Denial Memorandum

Install a 760 square foot in-ground swimming pool and 774 square foot pool patio on an undersized lot.

Denial Memorandum – Revised

Install a 760 square foot in-ground swimming pool (with no patio) on an undersized lot.

SWIMMING POOL GRADING PLAN
 TAX LOT 8 BLOCK 70
 24 RIDGE ROAD
 BOROUGH OF RUMSON
 MONMOUTH COUNTY, NEW JERSEY

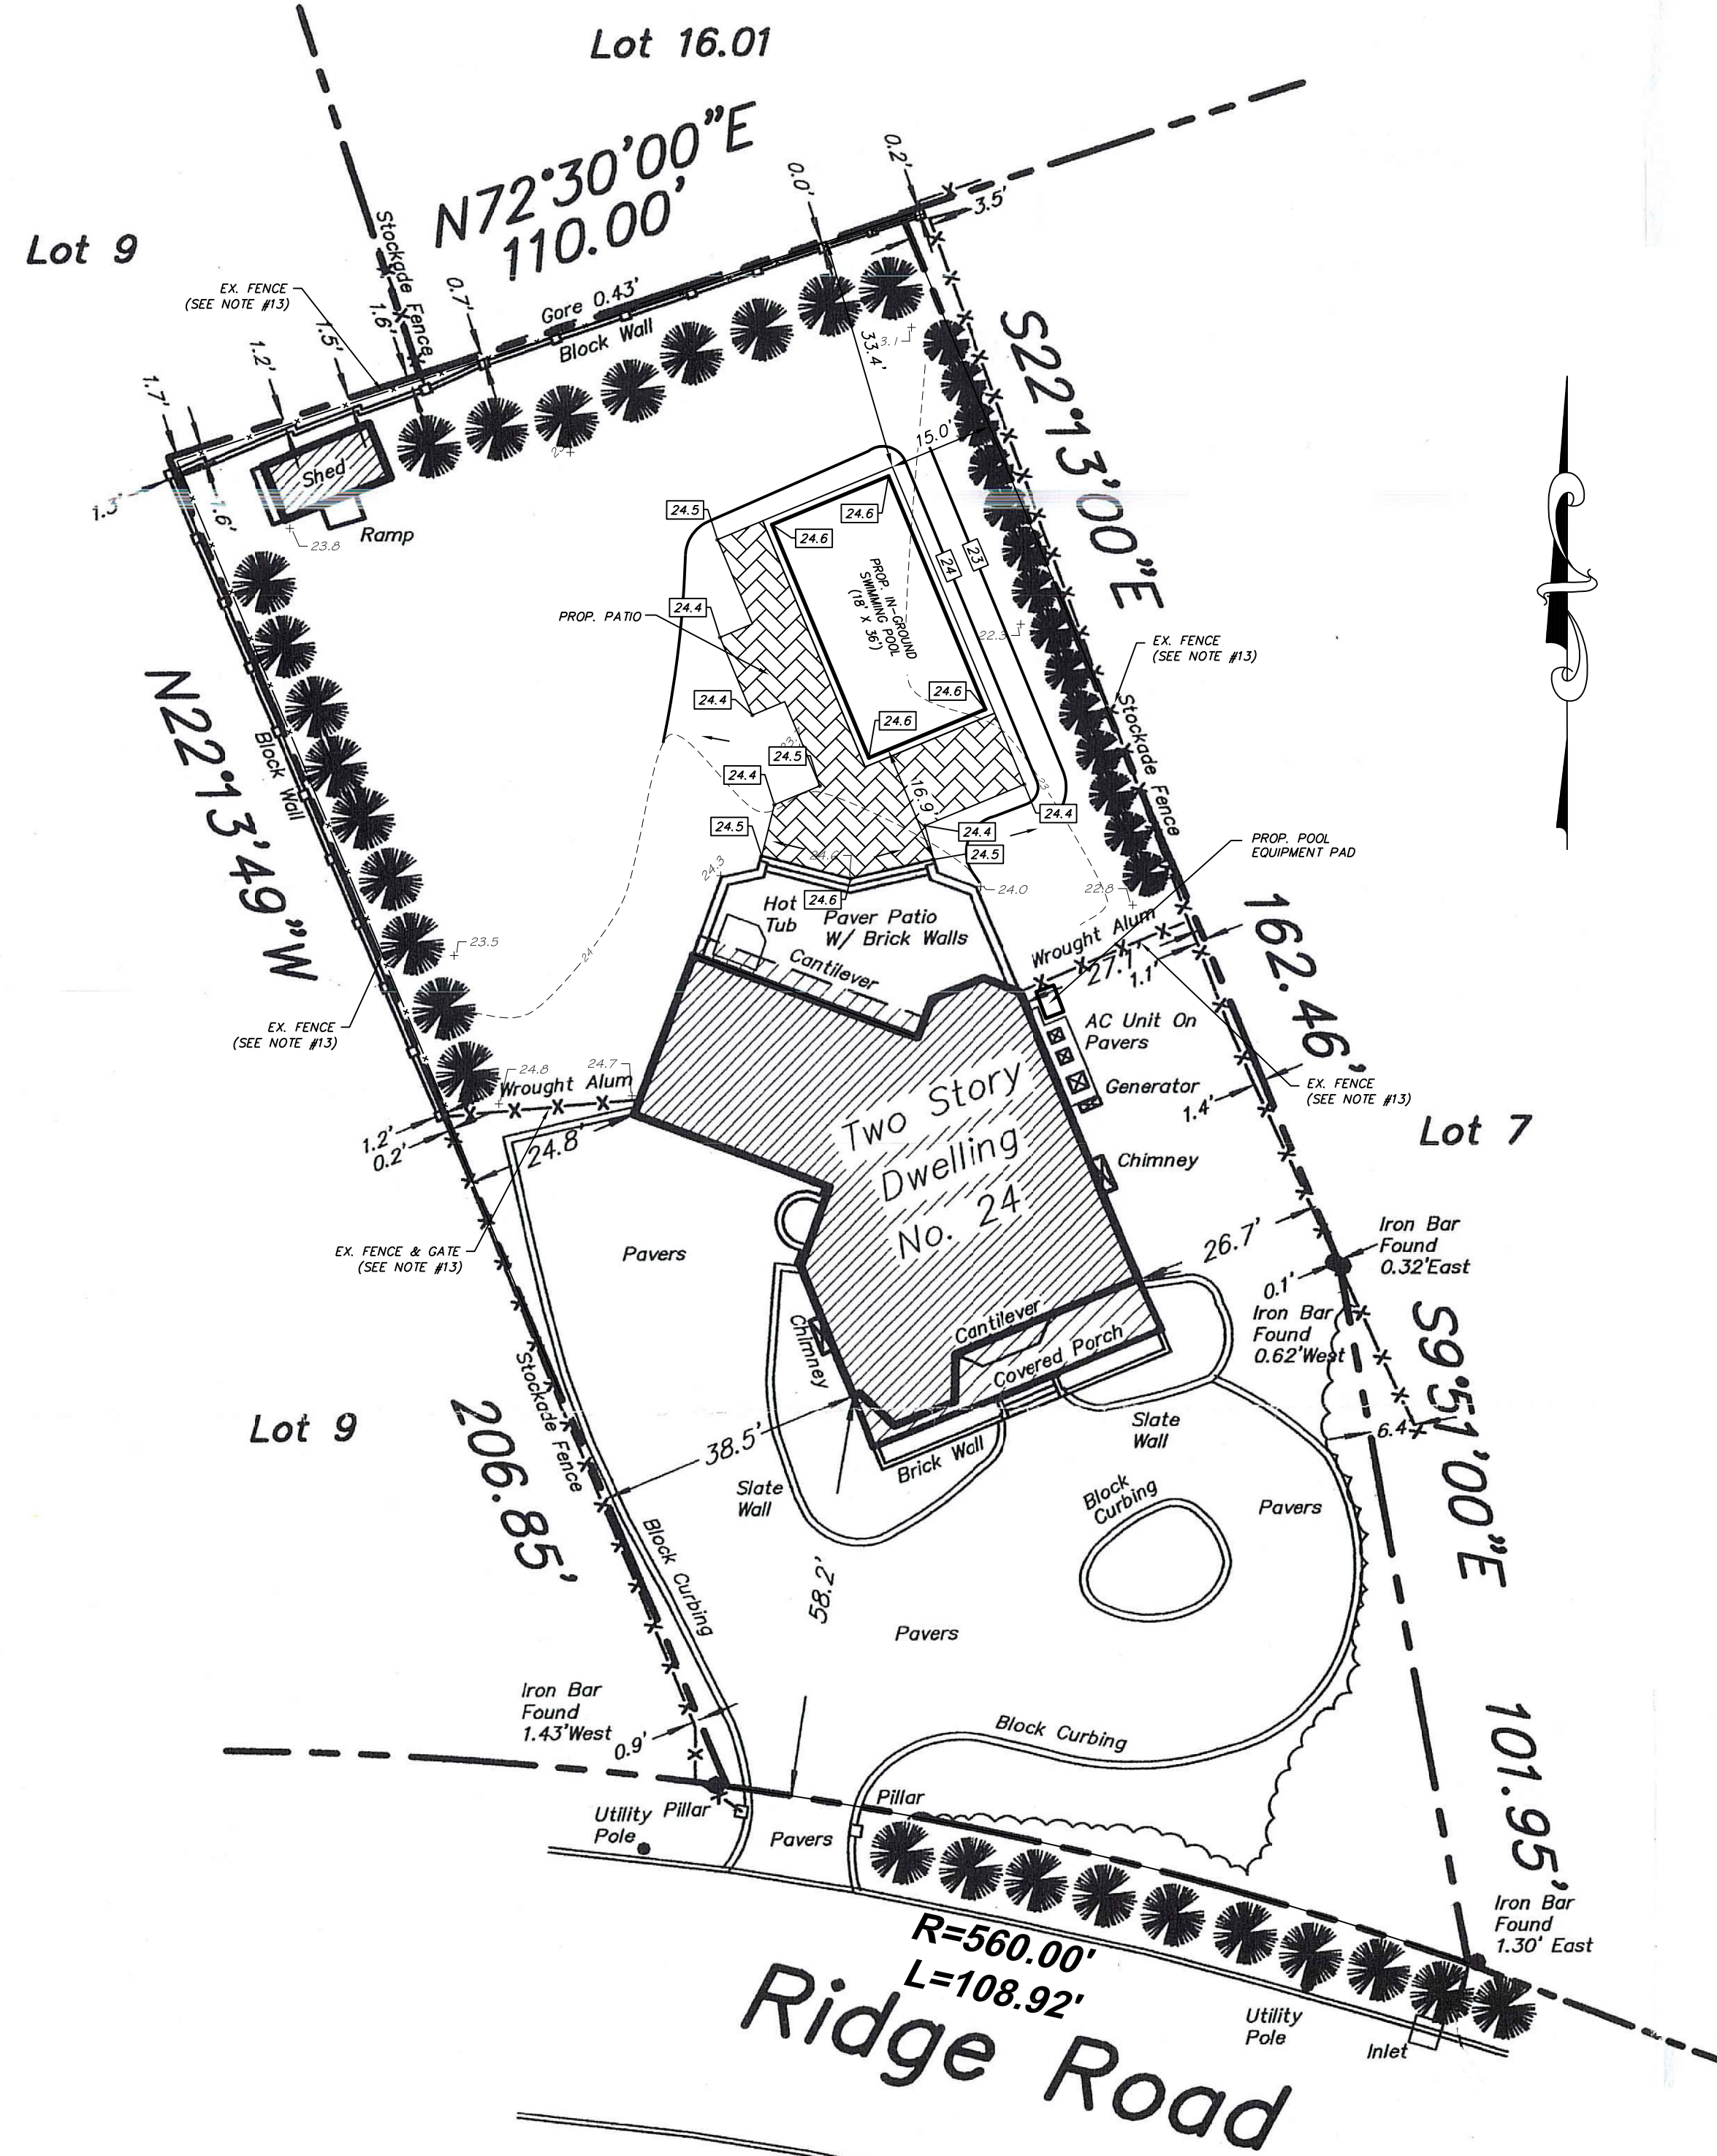
1. (Sched 5-4) Proposed lot coverage of 9,633 square feet, whereas 8,034 square feet is existing and 6,865 square feet is permitted. (*** Existing variance – Intensified***)
2. Proposed side yard accessory structure (pool) setback of 15 feet whereas 25 feet are required. (Borough ordinance 22-7.8g1). (*** New variance ***)

The variances identified above were evaluated based on the Survey of Property, prepared by Charles V. Bell Associates Inc., signed by Charles V. Bell (unsealed), dated June 12, 2012, no revisions, one sheet; and Swimming Pool Grading Plan prepared by MGC Associates, signed & sealed by Gary Chiang, P.E., dated January 8, 2023, last rev (2) March 15, 2024, consisting of one (1) sheet.

SWIMMING POOL GRADING PLAN
 TAX LOT 8 BLOCK 70
 24 RIDGE ROAD
 BOROUGH OF RUMSON
 MONMOUTH COUNTY, NEW JERSEY

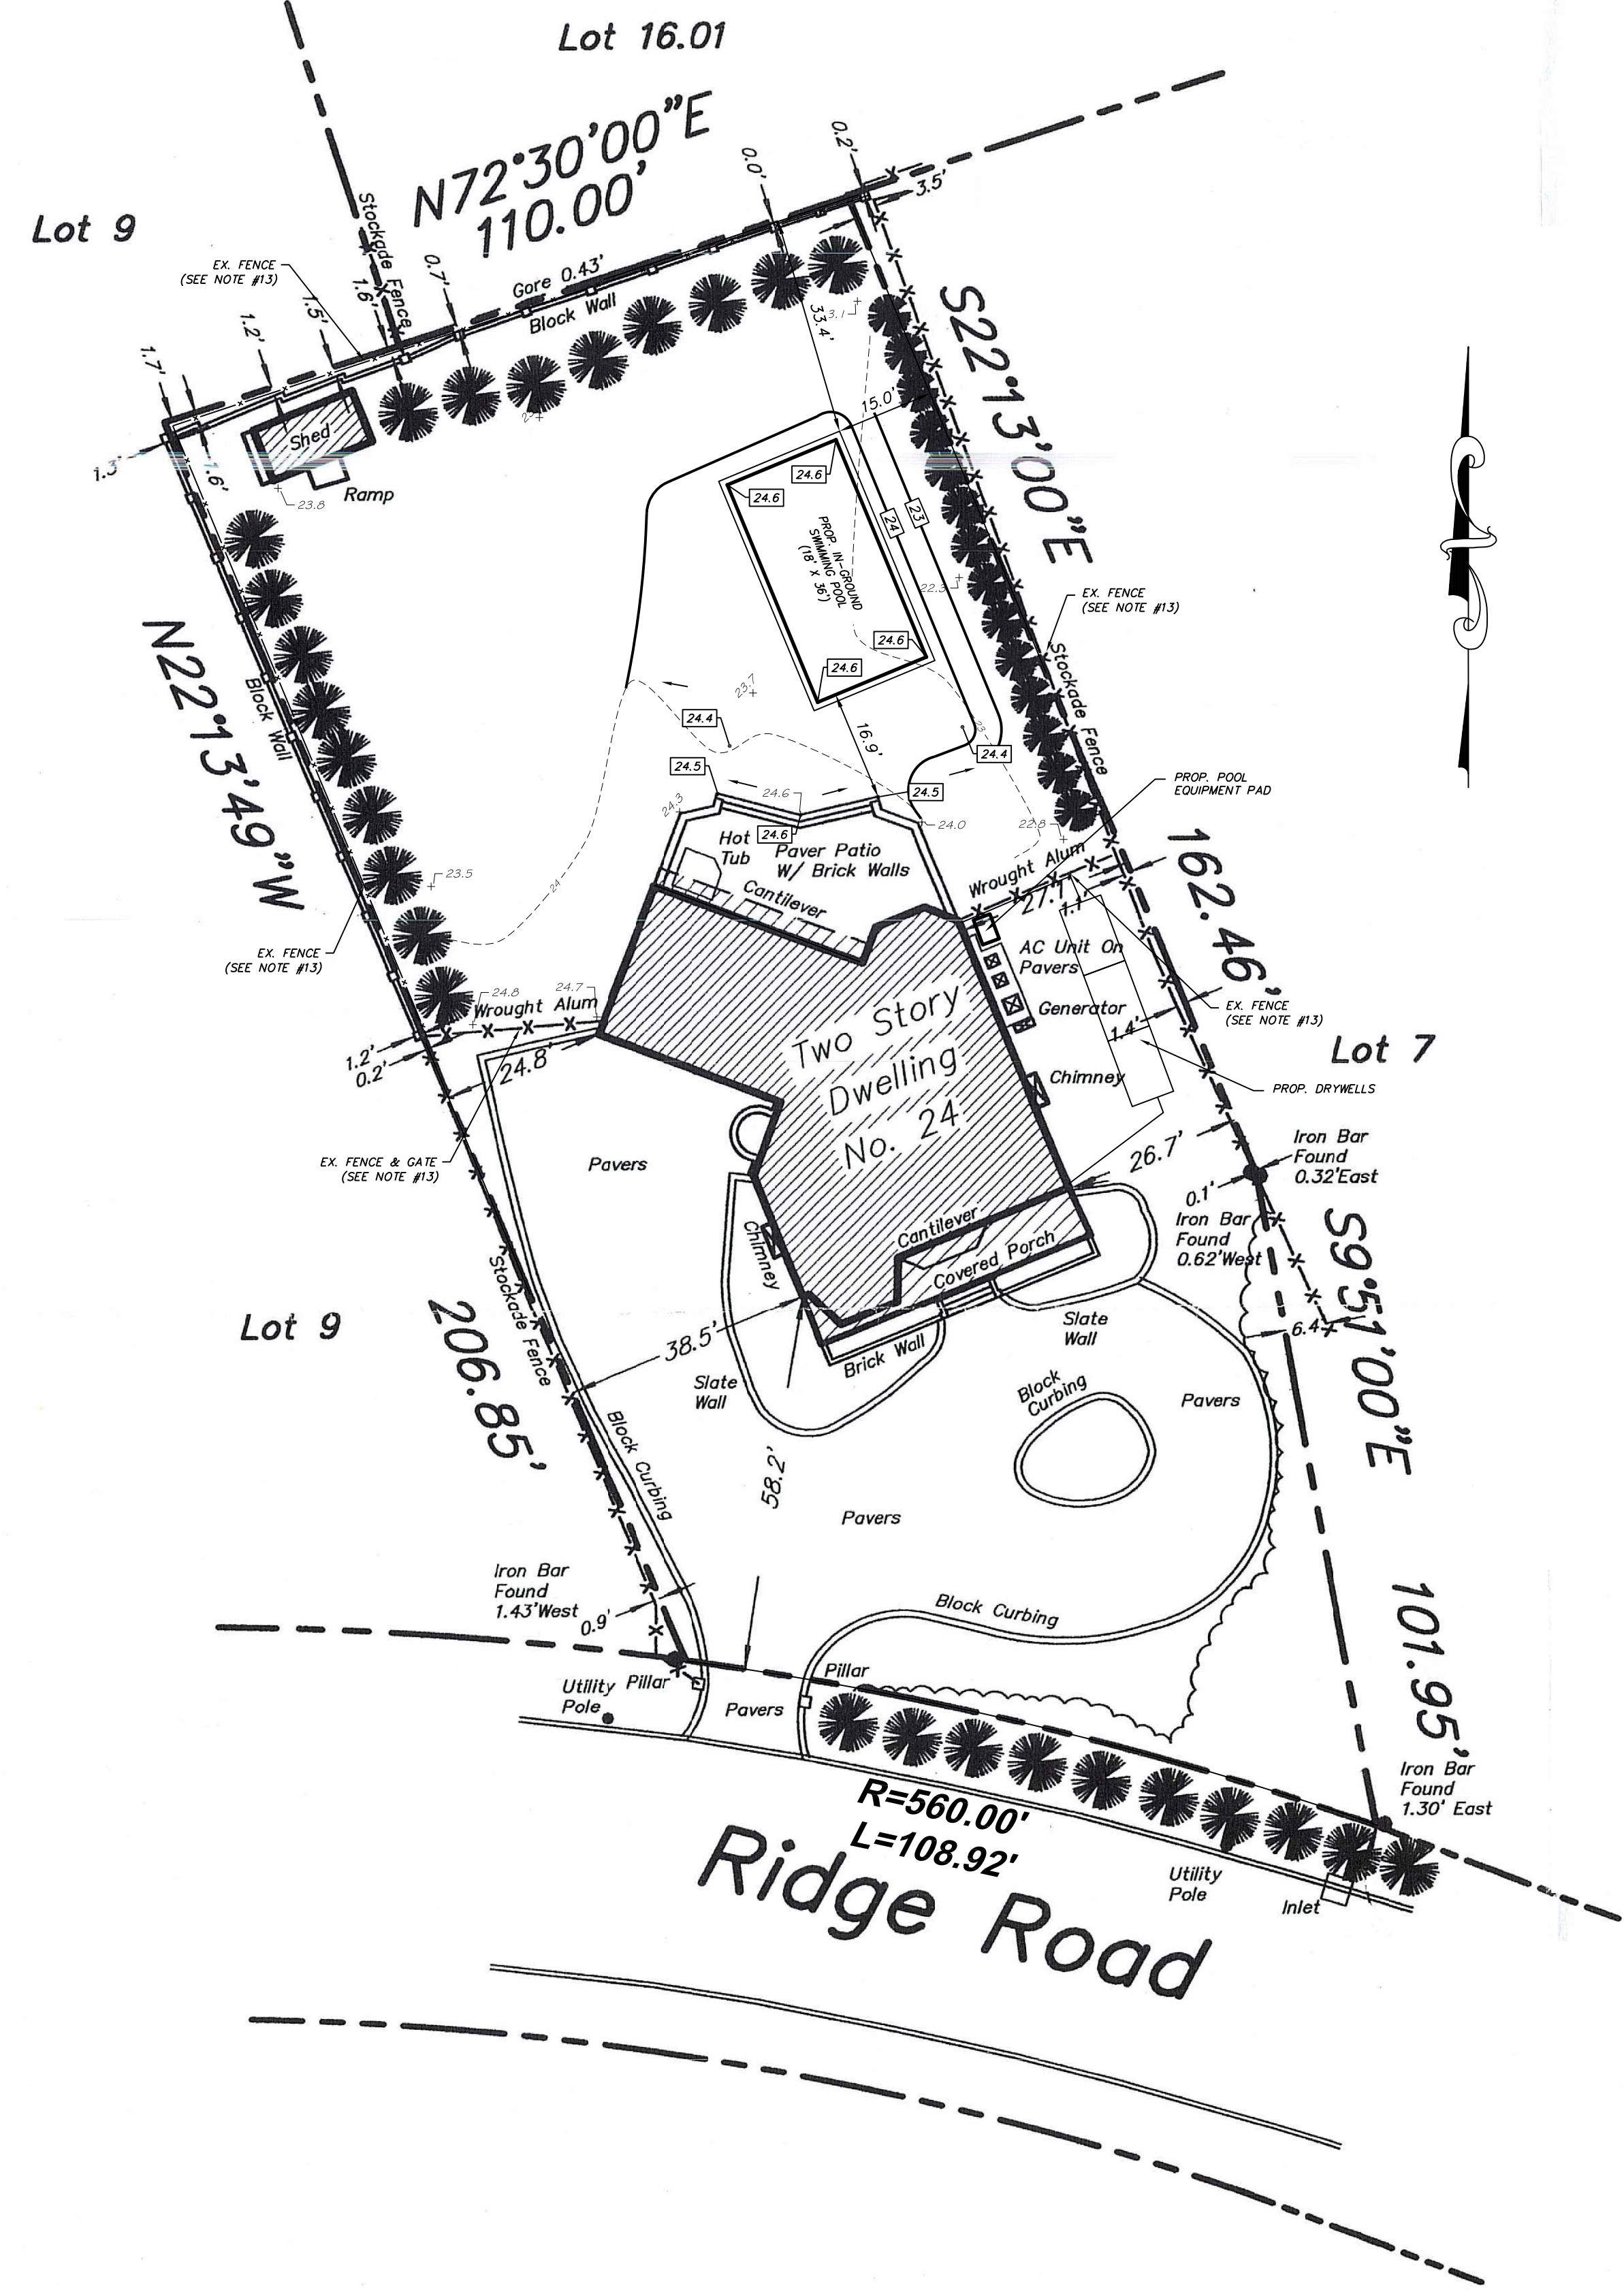
1. (Sched 5-4) Proposed lot coverage of 8,859 square feet, whereas 8,084 square feet is existing and 6, 865 square feet is permitted. (*** Existing variance – Intensified***)
2. Proposed side yard accessory structure (pool) setback of 15 feet whereas 25 feet are required. (Borough ordinance 22-7.8g1). (*** New variance ***)

The variances identified above were evaluated based on the Survey of Property, prepared by Charles V. Bell Associates Inc., signed by Charles V. Bell (unsealed), dated June 12, 2012, no revisions, one sheet; and Swimming Pool Grading Plan prepared by MGC Associates, signed & sealed by Gary Chiang, P.E., dated January 8, 2023, last rev (3) June 12, 2024, consisting of one (1) sheet.

No.	Date	Revision	By	Chk.
3	6/1/24	REV. TO REDUCE IMPERVIOUS AREA		
2	3/15/24	REV. TO PROVIDE ZONING CHART		
1	2/20/24	REV. IN ACCORDANCE WITH TWP 1/9/24 LETTER
